# **WATER TREATMENT ASSESSMENT**

**Heavener Utility Authority**

**Water Treatment Plant**

**August 28, 2019**

Figure 1: Maximum daily CFE turbidity values reported in the Authority's monthly operating reports

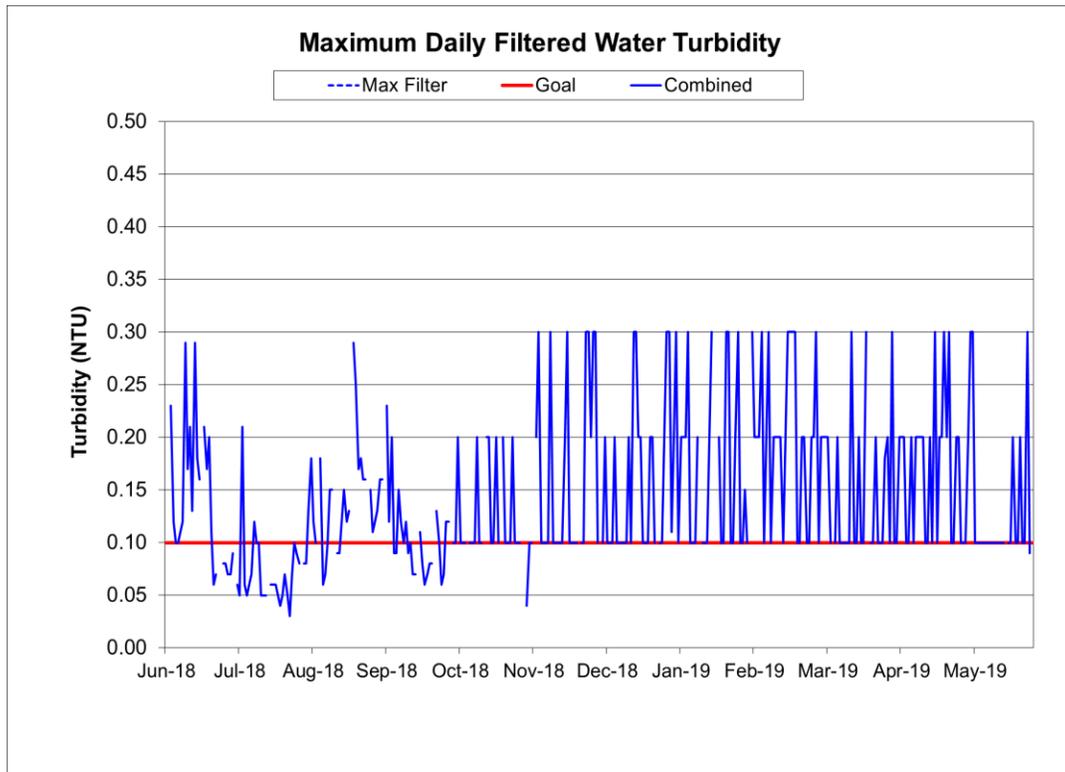
daily finished water turbidity data does not meet the optimized goal of 0.1 NTU or less 95 percent of the time. The regulated value for finished water turbidity is 0.3 NTU or less for 95 percent of all of the required monthly readings. The maximum daily finished water turbidity data is meeting the regulated requirement of 0.3 NTU or less 100 percent of the time. However, the CFE turbidity data caps at 0.3 NTU, as shown in Figure 1.

In addition, beginning in October 2018, values are rounded to the nearest tenth. Therefore, it is unknown if the data submitted is an accurate representation of CFE turbidity for the specified timeframe. Also, the CFE turbidity data from the supervisory control and data acquisition (SCADA) system could not be accessed, and DEQ personnel could not verify the data or compare it to MOR values.

Figure 2: The percentage of days in each month the Authority meets the secondary standard for manganese

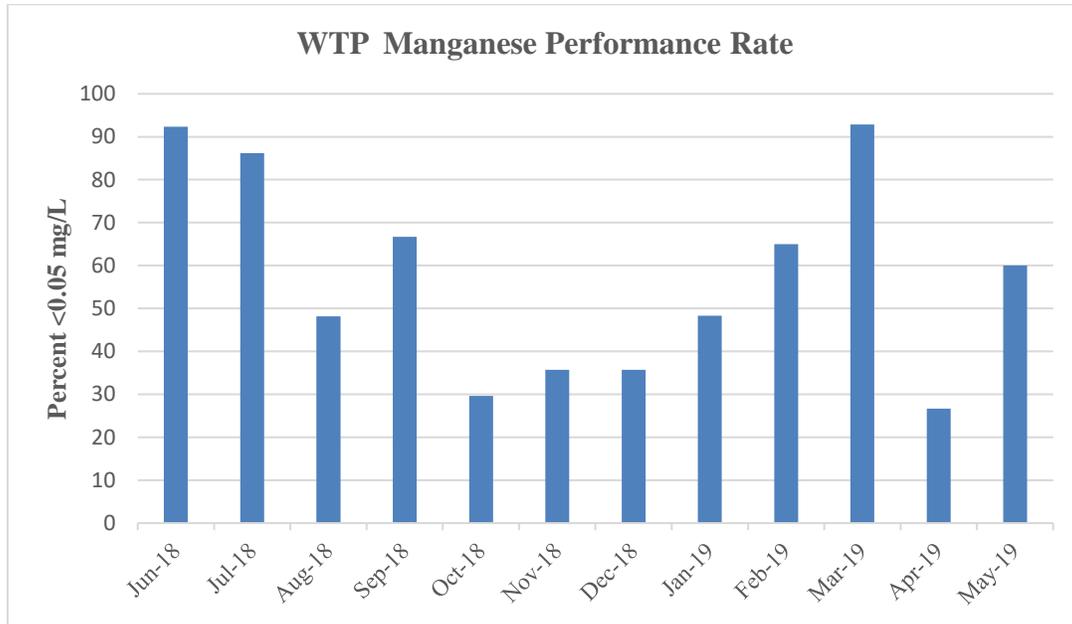
According to Figure 2, the performance rate for removing manganese decreased significantly in cooler months. October 2018 and April 2019 were the two worst-performing months in the last year. The average manganese concentration in the raw water was also the highest in these two months, demonstrating inadequate treatment processes for manganese removal.

Figure 5: Manganese samples from Heavener WTP major unit processes on August 28, 2019

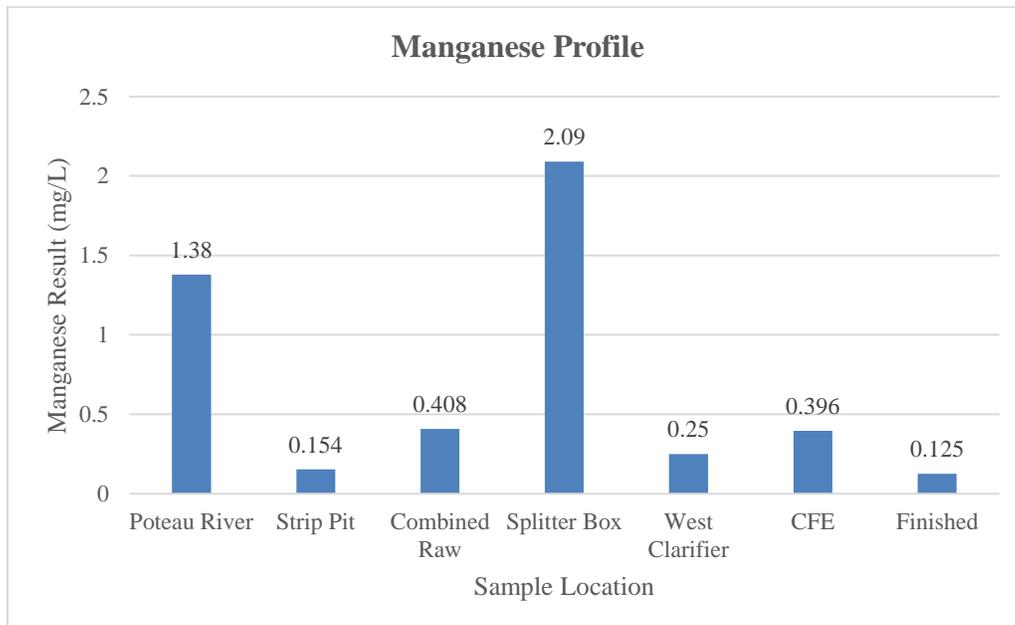
According to results, the WTP removed 69.3 percent of manganese present in the combined raw water. The finished water manganese concentration was 0.125 mg/L, which is two and a half times higher than the secondary MCL for manganese. The concentration of manganese from the Poteau River water was approximately 9 times higher than the concentration from the strip pit. Although the WTP was able to achieve some removal of manganese, the sample results indicate that the WTP was not able to meet the secondary MCL for manganese that day. Therefore, it appears that manganese is causing aesthetic effects in the distribution.

Parameters such as time and pH can change the amount of manganese removed by oxidation. Currently, the Authority injects potassium permanganate in the aeration basin to oxidize manganese, so it can be removed by sedimentation and filtration. Sufficient contact time must be provided to allow all of the potassium permanganate to react with manganese. Moving the potassium permanganate injection point upstream would increase the contact time and may improve manganese removal. The industry standard for this process is to add 1.9 grams of potassium permanganate for each gram of manganese removed. This proportion can vary depending on pH, as a higher pH may enable the potassium permanganate to be more effective. Figure 6 shows the results from the pH samples taken during the assessment.

Figure 6: pH samples from Heavener WTP major unit processes on August 28, 2019

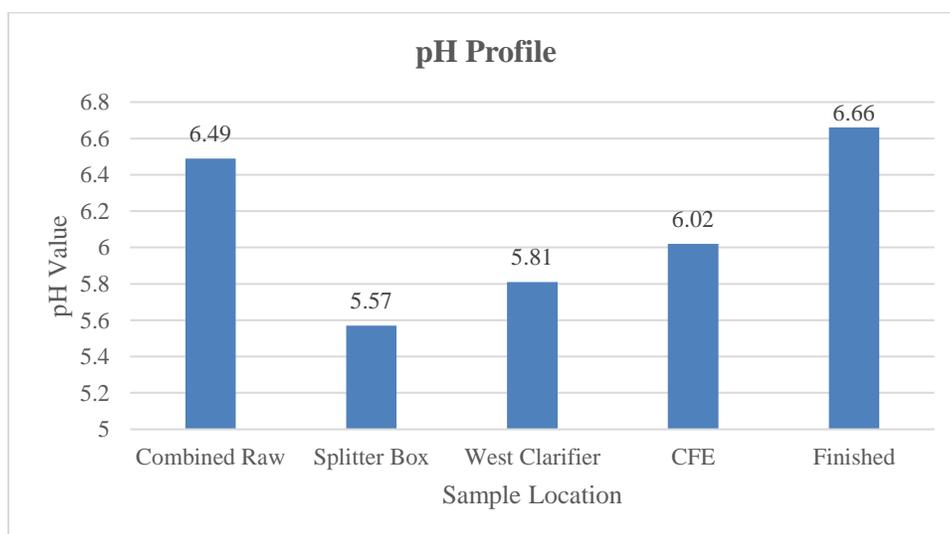
After the two raw water sources combine and enter the aeration basin, the Authority adds potassium permanganate for manganese oxidation near the basin inlet and ferric chloride to lower pH for organics removal near the outlet. The pH is later increased with caustic soda before it enters the clearwell. A further study would need to be performed to determine the extent that the change in pH is affecting the potassium permanganate’s ability to oxidize manganese. Typically, the oxidation capabilities of potassium permanganate tend to increase at a higher pH. If it is determined that potassium permanganate is not effective given the normal operating pH value in the WTP, the Authority should reassess its treatment strategy for manganese removal.

Figure 7: The calculated capacities of each major unit process

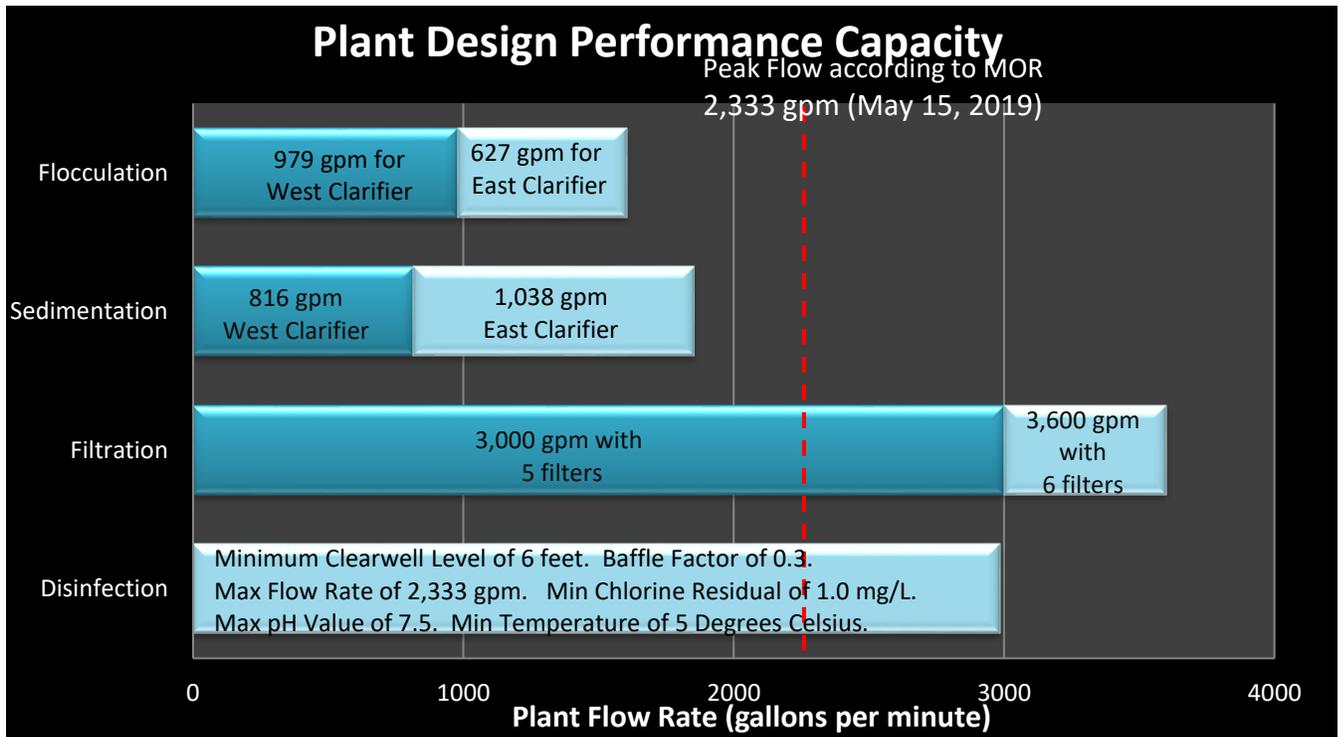
The capacities are based on field measurements and dimensions provided by the Authority and plant operators. According to plant operators, the capacity of both clarifiers operating simultaneously was rated at 3.0 MGD after their construction. A capacity of 3.0 MGD still does not meet the demand from the maximum daily flow rate.

- The clarifiers have the capacity to meet average daily demands but not the maximum day demand.
